SITE INSTRUCTION

PROJECT: HAMPTON MANOR
25 BAKER HILL BLVD
STOUFFVILLE, ONTARIO

SITE INSTRUCTION: E-14

DRAWN	CM	CHECKED	MG	SCALE	1:100
DATE	SEPT. 2015	PROJECT	14-016	DRAWING	E-2A
				OF	12

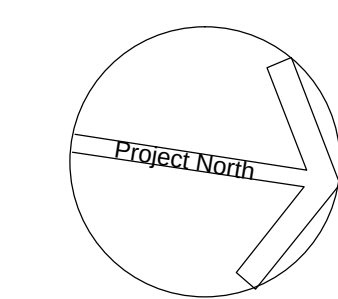
1.0 Reference Drawing E-2A (P1 Level - 2A) Issued

- 1.1 Relocate: Power connection and control panel for sanitary sump pit 'P-8' and for storm sump pump 'P-9'.
- 1.2 Relocate: Insulate and electrically trace for 75Ø sanitary discharge and for 100Ø storm discharge.

TITLE	3RD-5TH FLOOR PLANS - A ELECTRICAL		
PROJECT	PROPOSED RESIDENTIAL DEVELOPMENT 25 BAKER HILL BLVD.		
	ROYAL PINE HOMES STOUFFVILLE, ONTARIO		
DRAWN	CM	CHECKED	MG
DATE	SEPT. 2015	PROJECT	14-016
		SCALE	1:75
		DRAWING	E-5A
		OF	12

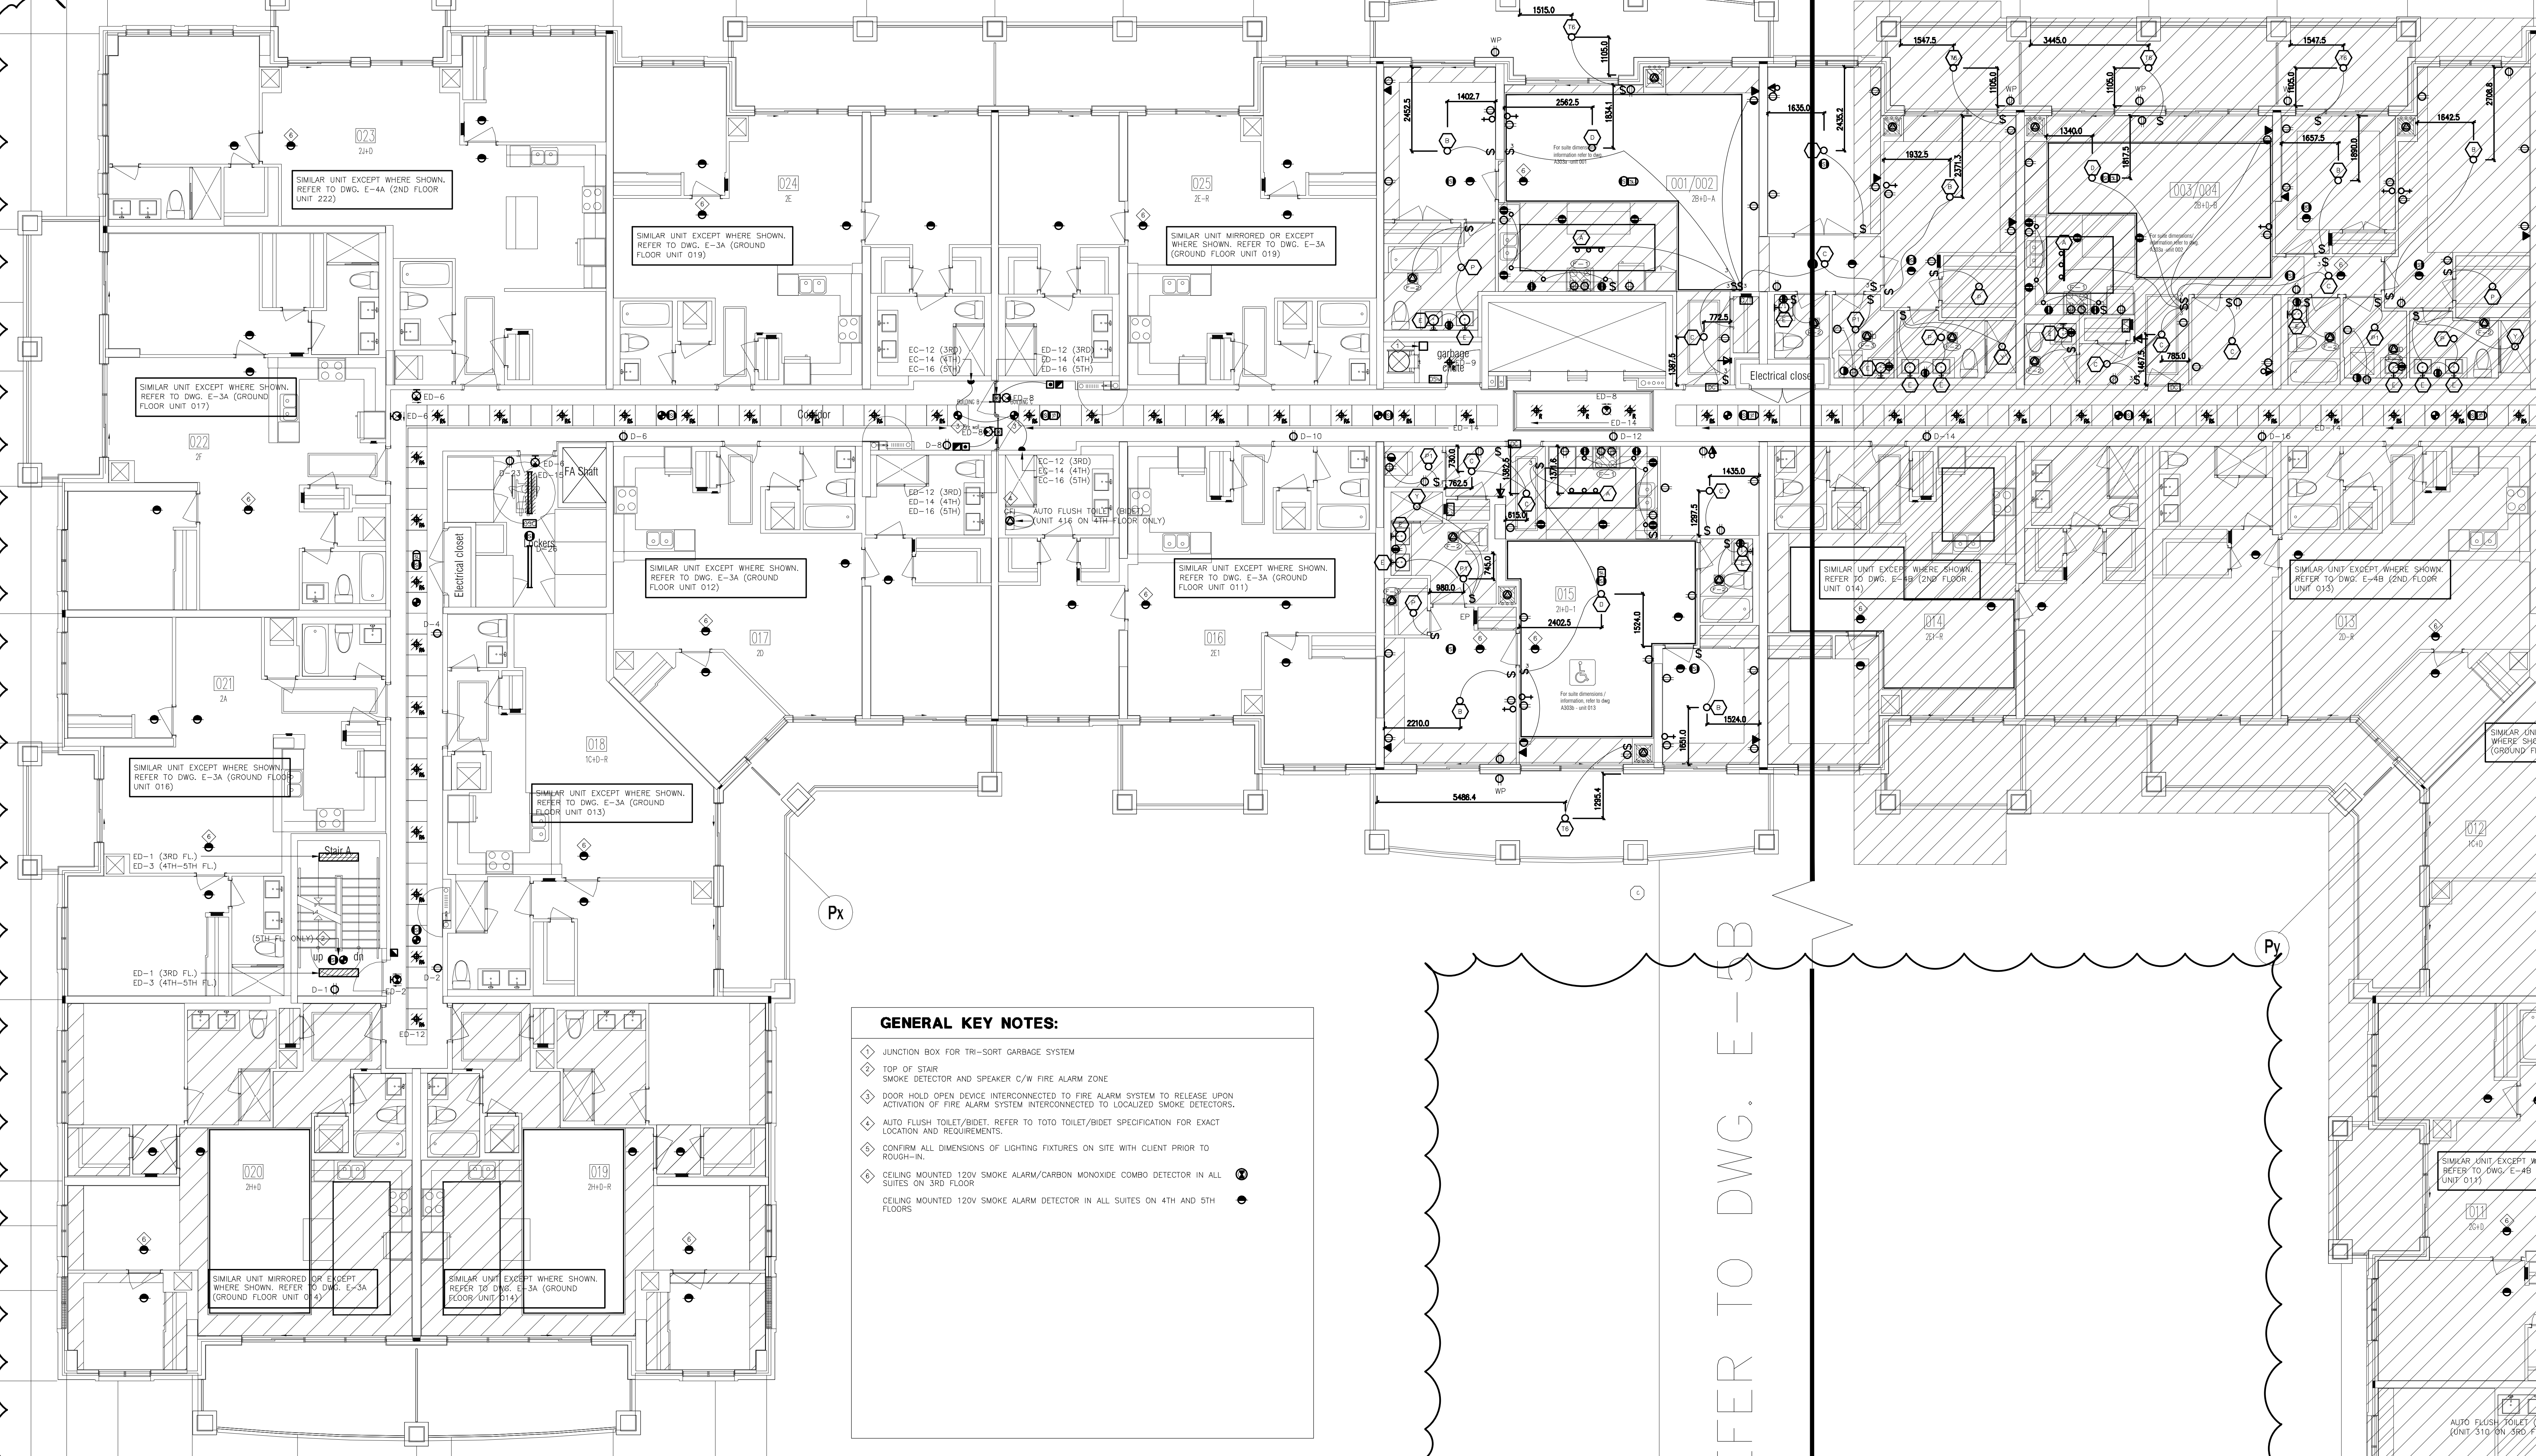
4.0 Reference Drawings E-5A and E-5B (3rd to 5th Floor – A and B) Issued

4.1 Clarify: 120V smoke alarm/carbon monoxide combo detector in suites on 3rd floor
120V smoke alarm detector in suites on 4th and 5th floor

4.2 Add: One (1) fire alarm strobe light in suites 001/002 and 003/004

4.3 Add: Key note #6

DRAWN CM	CHECKED MG	SCALE 1:75
DATE SEPT. 2015	PROJECT 14-016	DRAWING E-6A OF 12

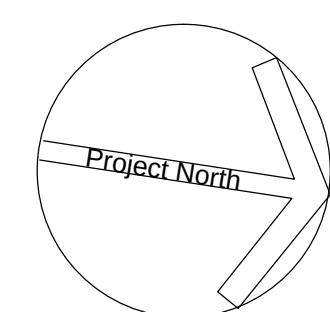
5.0 Reference Drawings E-6A and E-6B (6th Floor – A and B) Issued

5.1 Clarify: 120V smoke alarm/carbon monoxide combo detector in suites on 6th floor

5.2 Delete: One (1) fire alarm strobe light in suites 613 and 616
